Access Compliance Report Public Rights-of-Way (Curb Ramps)

Main Street: N/A Cross Street: DODGE_AVE Location: NE

ADA ID: RPAT220222160231 Ramp Type: Type 3 - Combination 1 Initial Pass/Fail: Fail Overall Compliance: No Severity Score: 5

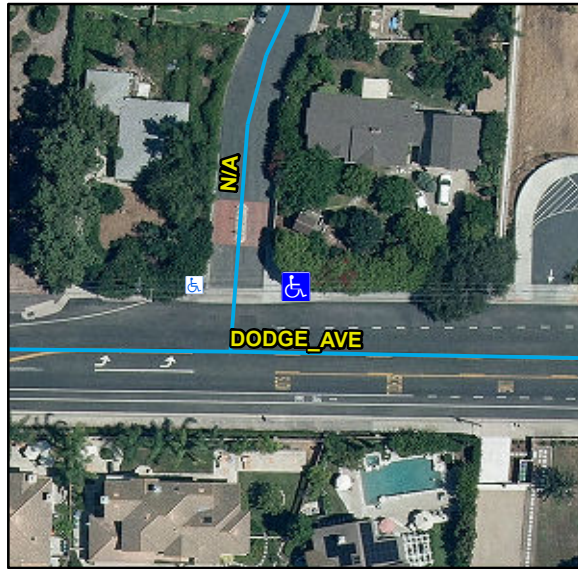
Compliance	Description	Data	Compliance	Description	Data
N/A	Ramp Length LT (in)	85	N/A	Ramp Length RT (in)	84
No	Ramp Width LT (in)	46	No	Ramp Width RT (in)	46
Yes	Ramp Run Slope LT (%)	6.7	Yes	Ramp Run Slope RT (%)	6.1
Yes	Ramp Cross Slope LT (%)	0.6	Yes	Ramp Cross Slope RT (%)	0.5
N/A	Ramp Length (in)	36	N/A	Flare Type LT	
Yes	Ramp Width (in)	48			N/A
Yes	Ramp Run Slope (%)	7.2	N/A	Flare Slope LT (%)	N/A
Yes	Ramp Cross Slope (%)	0.9	N/A	Flare Traversable LT	N/A
N/A	Landing Present	N/A	N/A	Flare Type RT	
N/A	Landing Length (in)	N/A			N/A
N/A	Landing Width (in)	N/A	N/A	Flare Slope RT (%)	N/A
N/A	Landing Run Slope (%)	N/A	N/A	Flare Traversable RT	N/A
N/A	Landing Cross Slope (%)	N/A	N/A	DWS Provided	N/A
N/A	Landing Movement Obstructed?	N/A	N/A	DWS Contrast	N/A
	Landing Movement Type	N/A	N/A	DWS Length (in)	N/A
N/A	Landing Shared	N/A	N/A	DWS Full Width	N/A
N/A	Clear Space	N/A		DWS Offset Type	N/A
N/A	Clear Space To Crosswalk (in)	N/A	N/A	DWS Offset Left (in)	N/A

Remove & Replace Entire Ramp.
